TITLE ARC SUPPRESSION - DYNAMIC BRAKE RELAYS - EXPELLOR A/C		EXP. NO. 12505	FILE CODE 111-71
PART NO. 6046139A		EFFECTIVE Immediately	
PART NAME U/C SELECTOR RELAY		ORIG. NO. 111-22011	COPIED TO
USE OF E.M. CHANGE CORRECTION STOP ORDER/RELEASE NEW DRAWING REVISION DRAWING VARIATION OBSOLETE NOTICE USE AS NOTED		JOB NO. 10-0242	NO. 5 6 9 2 1 1 4 1
DISPOSITION OF DROK		CUSTOMER'S ORDER NO. ODM 572860	
CHECK ELECTRIC APPLIED	NO	CUSTOMER	
DATE TO BE APPLIED	NO	R.C.A.F.	
NOT AFFECTED	NO	TYPE AIRCRAFT EXPELLOR	
DEFINITION	NO	AIRCRAFT REGISTRATION NO. 2309	
REWORK	NO	DATE 7 Jan 58	
NO REWORK	NO	BY/ISSUER W.J.	
NO REWORK	NO	RES. NO.	
NO REWORK	NO	CUSTOMER W.J.

The following modification will be installed in Expeditor ~~2309~~ ²³⁰⁹ only on an Engineering prototype basis.

FIG. 1

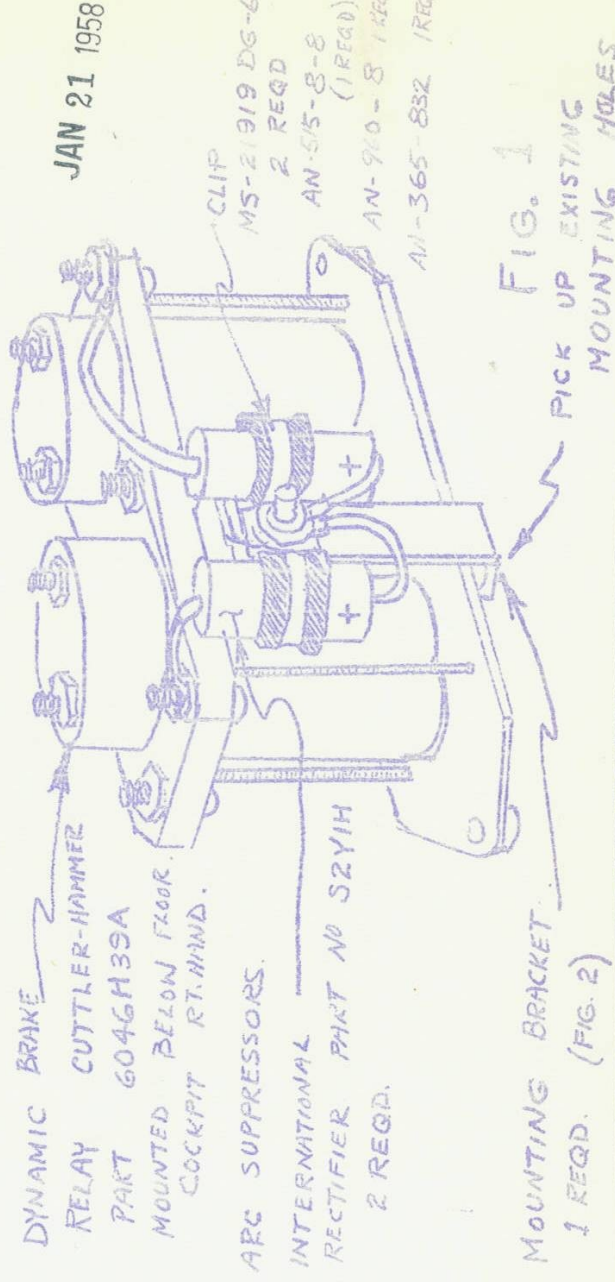
1. Install placard B.W part number 111-22010 on main instrument panel in accordance with B.W drawing 111-22011.
2. Install 2 only arc suppressors International Rectifier Co. Part number S2Y1H per Fig. 1.
3. Ref. Ame letter 1038 JU-(LC/R04), 12 Feb. 1957 and Son. Trenton UCR. #6253/A202.

SEE FIG 3 FOR WIRING

FIG. 3

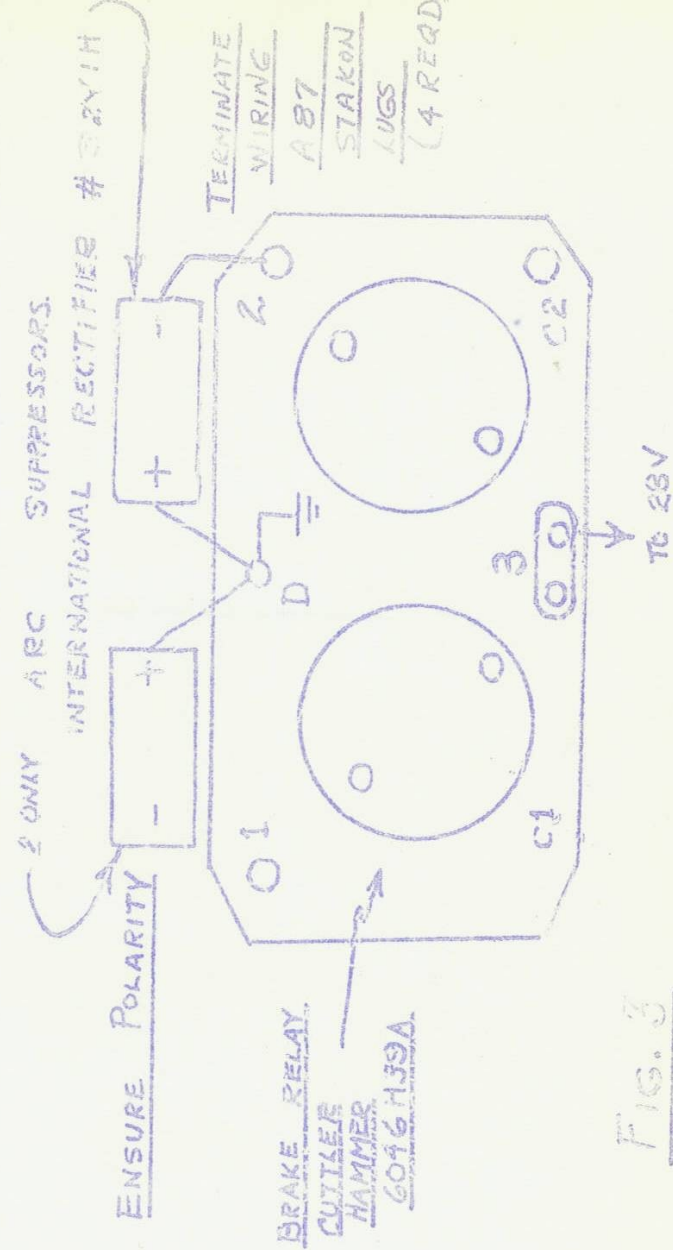
BRACKET SUPPRESSOR

MOUNTING
24ST .040
AL. ALLOY
FINISH: PRIME
